CHANGE APPLICATION (MINOR CHANGE) TO THE DEVELOPMENT PERMIT FOR RECONFIGURING A LOT (1 LOT INTO 220 LOTS, NEW ROAD, 1 PARK LOT & 2 DRAINAGE LOTS) – 3L HICKLING ACCESS, GORDONVALE – DIVISION 1

PROPOSAL: CHANGE APPLICATION (MINOR CHANGE) TO THE DEVELOPMENT PERMIT FOR RECONFIGURING A LOT (1 LOT INTO 220 LOTS, NEW ROAD, 1 PARK LOT & 2 DRAINAGE LOTS)

LOCATION OF SITE: 3L HICKLING ACCESS, GORDONVALE

DATE OF CHANGE APPLICATION: 2 MAY 2024

DRAPER ROAD LAYOUT PLAN - SITE TO DEMPSEY STREET

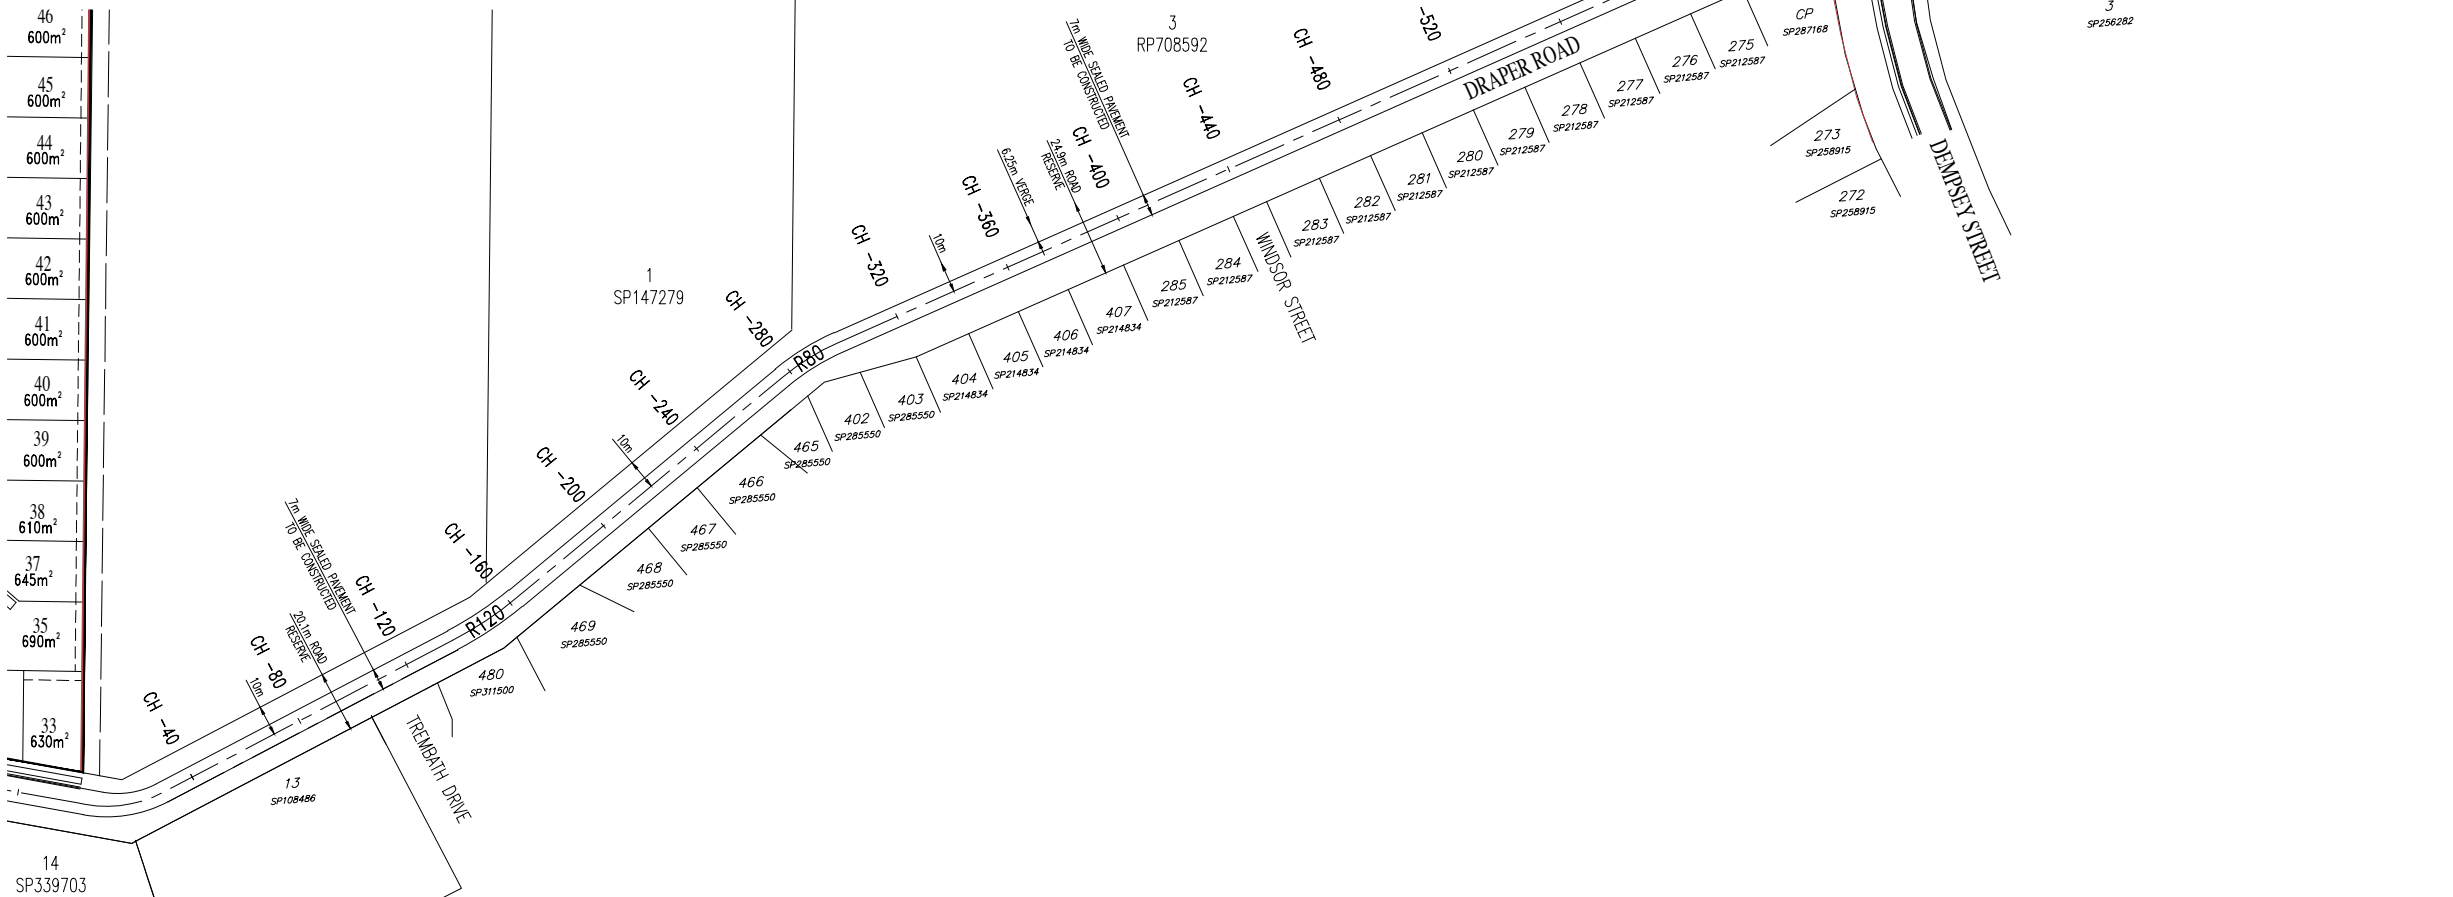
- a. Provide a full detailed design of Draper Road from the development site to the intersection of Draper Road / Dempsey Street ~~for a Major Collector Standard~~ to a Minor Collector Bus Route Standard as defined in Council's FNQROC Development, as part of the first application for Operational Works. Associated landscaping must be in accordance with the FNQROC Development Manual and the FNQROC CRC Specific Requirements for D9 Landscaping.

- b. Design and construct a 7m sealed pavement width along Draper Road from the development site ~~access~~ to the intersection of Draper Road / Dempsey Street that is compatible with the ultimate form of the road as an interim arrangement. The works must be undertaken prior to Council approval of the Plan of Survey for the first stage of development. Services are required to be installed suitable for the future road upgrade to a ~~Major Collector Standard~~ Minor Collector Bus Route Standard.
